## DESIGN REVIEW COMMISSION MEETING

1. Applicant: Midtown Ventures, LLC  
Location: 813-823 N. 4<sup>th</sup> Street  
Request: Midtown Ventures LLC, is requesting a second meeting with the Design Review Commission for a proposed 3-Story, 23,564 sq.ft. mixed use building in the MO (Midtown Overlay District).  
(DR-4-21)

**DESIGN REVIEW COMMISSION  
STAFF REPORT**

FROM: TAMI STROUD, ASSOCIATE PLANNER  
DATE: AUGUST 26, 2021  
SUBJECT: DR-4-21: REQUEST FOR THE SECOND MEETING WITH THE DESIGN REVIEW COMMISSION FOR A MIXED-USE PROJECT (*COMPRISED OF A COMMERCIAL/MULTIFAMILY APARTMENT BUILDING*)

### **Applicant's Design Departure request:**

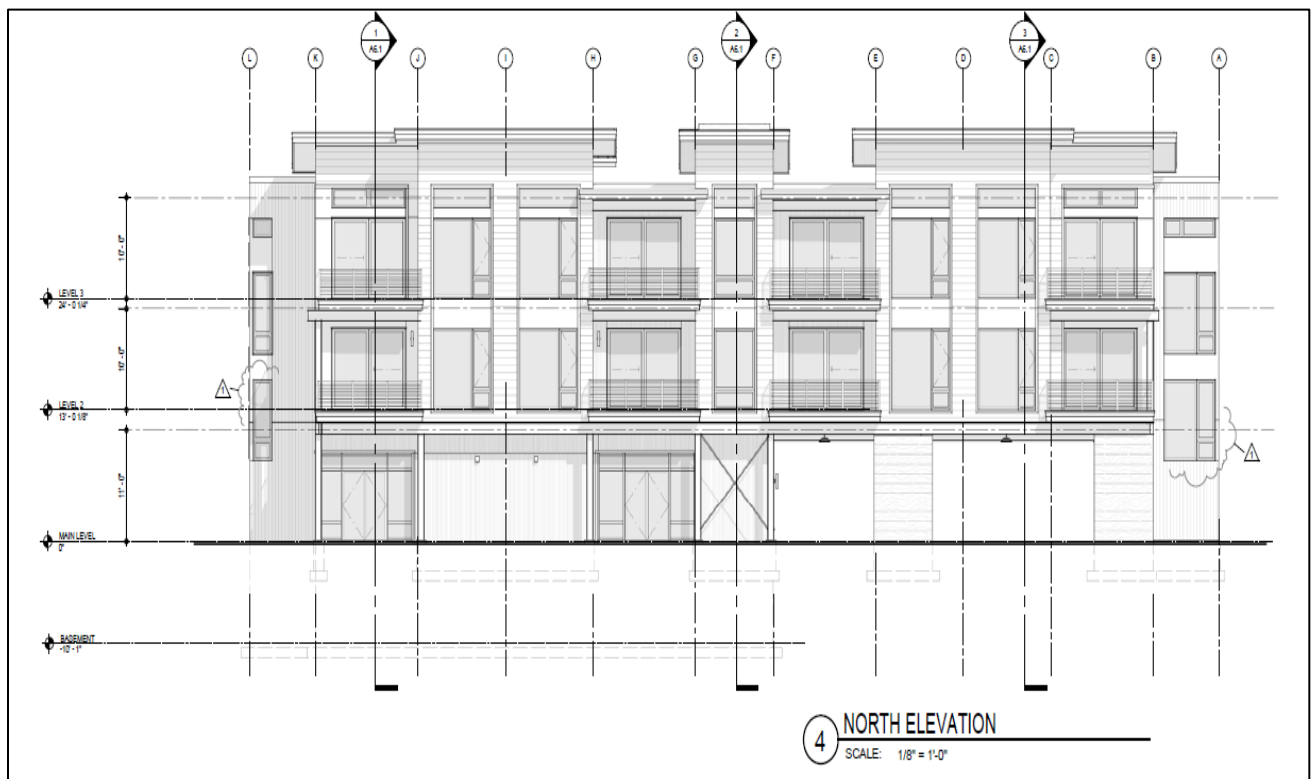
The applicant has requested a Design Departure for the Design Guideline requiring a minimum slope of 4:12 pitch and has requested the approval of a proposed 1:12 pitch for the mixed-use project (comprised a mixed-use project, one floor of commercial and 2 floors multifamily).

Roof pitch shall have a minimum slope of 4:12 and a maximum slope of 12:12.

As per the MO design guidelines, a 4:12 roof pitch is the minimum allowable pitch for any roof within this district.

We believe that in this particular situation, a 4:12 roof pitch would not only be detrimental to the project and its aesthetics, it would also have a negative effect on the surrounding neighborhood. Our proposed design has standing seam metal roofing on a 1:12 roof pitch on the shed roof portions, which that lower roof pitch keeps our building within the prescribed building height for the Midtown Overlay District. This building will be the tallest building in the area, and our belief is that the lower roof pitch also helps to minimize the visual impact of this project and keep in scale with the overall intent of the MO District. The lower roof pitch also minimizes the amount of blank wall above the 3<sup>rd</sup> story windows and doors, which is preferable aesthetically.

**East Elevation – (OLD) Not Meeting Glazing Requirement:**

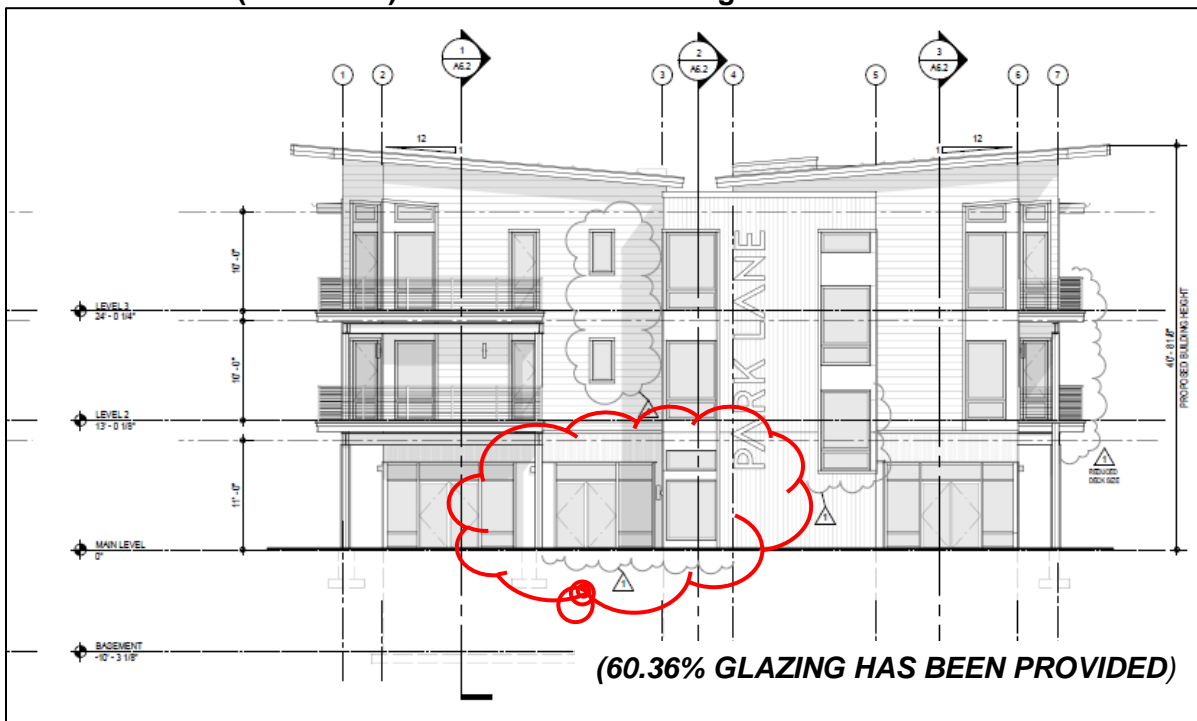
- Update the Narrative for the proposed project,
- Clarify the project boundaries,
- Clarify the design departure requests,
- Provide a landscape plan,
- Clarify amount of glazing provided along the 4<sup>th</sup> Street façade of building,
- Show parking lot screening,
- Provide buffering for the grassy area between grassy area and parking lot,
- Meet glazing requirements or request design departure,
- Consider providing a more pedestrian friendly storefront along 4<sup>th</sup> Street to be more compatible with the Midtown retail area

**East Elevation – (UPDATED) With Additional Glazing:**
